Dublin Cycling Campaign

15th November 2022

**RE: Ballymun/ Finglas to City Center Core Bus Corridor**

**An Bord Pleanála Case No. 314610**

Figure 9 ImageJ analysis showing 1.45m width for Section 5 Finglas.

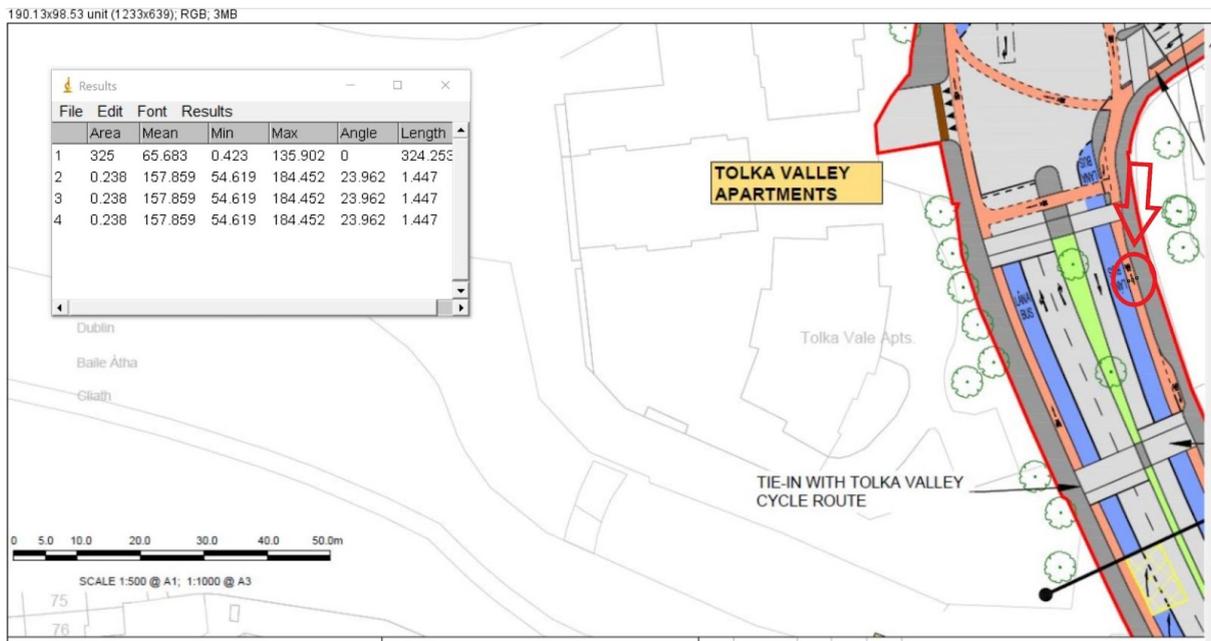
For example, the 1.45m (Figure 9) cycle track proposed in Section 5 (see specific comments below) is unacceptable on a road that has up to five lanes and a central median (see image).

It is regrettable that cycle track widths are sub-standard for long stretches of the Finglas Road e.g. between junctions with Wellmount Road and Tolka Valley Road where they measure only 1.45m. A width of 1.5m fails, as discussed below, to offer a good quality of service to people on bikes. This is disheartening to see where space for adequate widths is available in buffer or median strips e.g. B-2250 to 2400 and all along by Glasnevin Cemetery.
